Document 5D/IEEE-xx-E

PROPOSED MODIFICATIONS TO THE WORKING DOCUMENT TOWARDS
PDNR M.[IMT.RSPEC]

WORKING DOCUMENT TOWARDS A PRELIMINARY DRAFT
NEW RECOMMENDATION ITU-R M.[IMT.RSPEC]

Detailed specifications of the terrestrial radio interfaces of IMT-Advanced

Figure 7: Downlink/Uplink Pilot Structures for 1, 2, 4, and 8 Streams for Type-1 Subframe

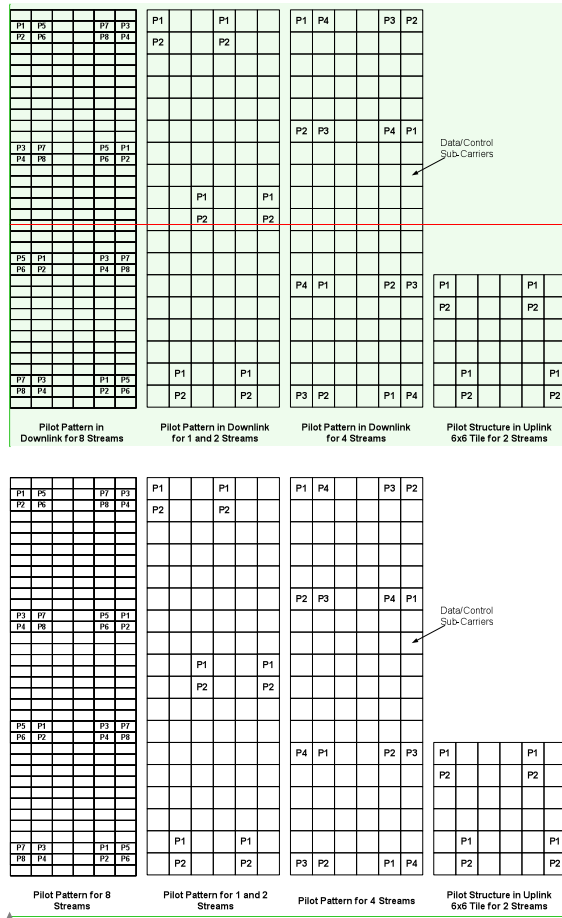
Jeongho Park 10/12/2 02:20 PM
Comment: The first three figures can be applied to UL cases, either. Delete this figure and use the next figure instead.

Figure 9: Bandwidth Request Procedure

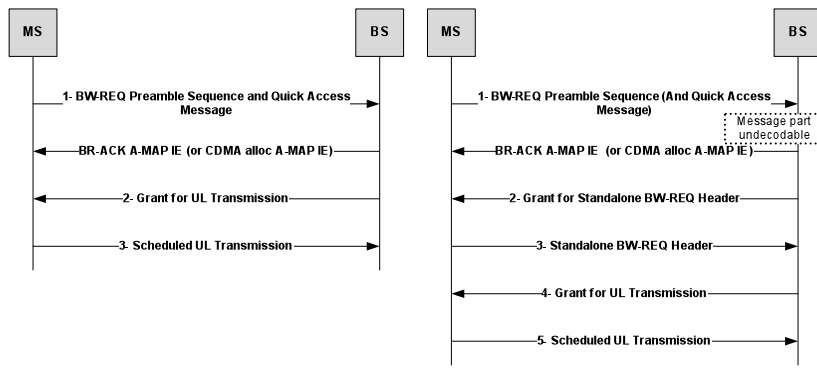
Jeongho Park 10/12/2 04:50 PM
Comment: Typo correction, 5 step procedure clarification, BR ACK A_MAP IE or CDMA alloc IE can be used (for D10). Delete this figure and use the next figure

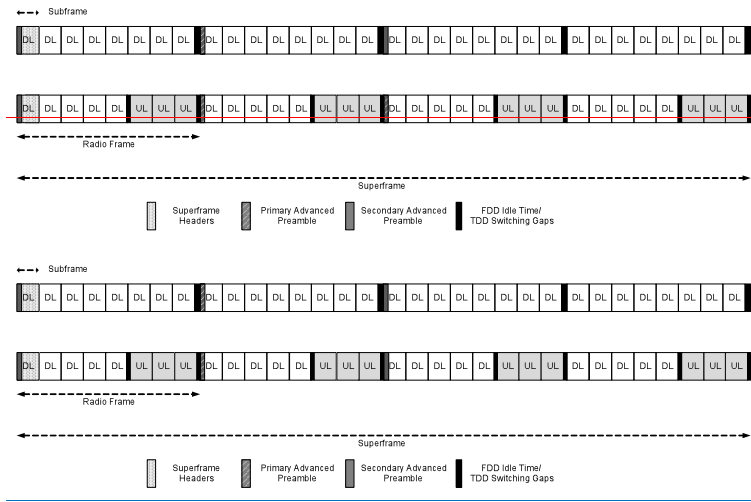
Comment: Correct the wrong sentence and picture

Figure 15: Structure of the WirelessMAN-Advanced Generic MAC Headers

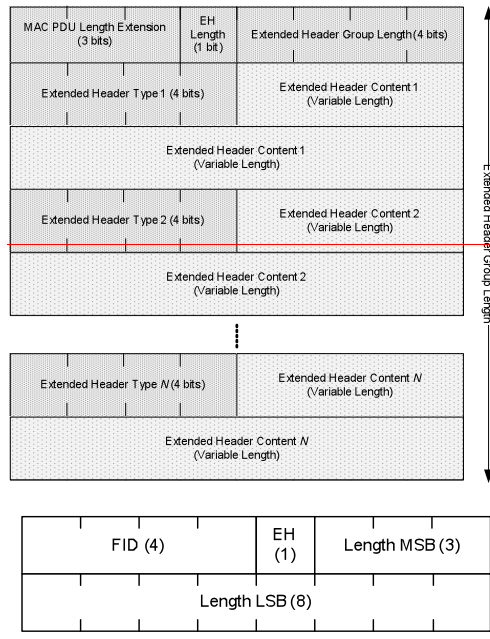
Comment: Header names have been changed

Figure 16: WirelessMAN-Advanced Handover Procedure

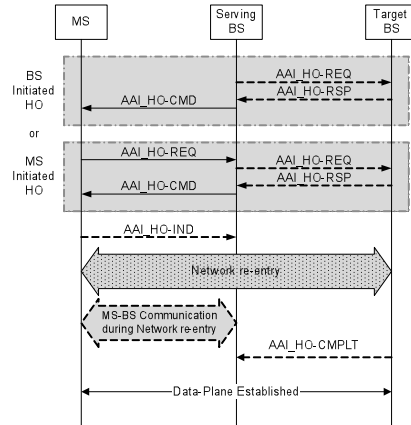
Comment: Unnecessarily detailed description, and this text is not relevant with the Figure 16.
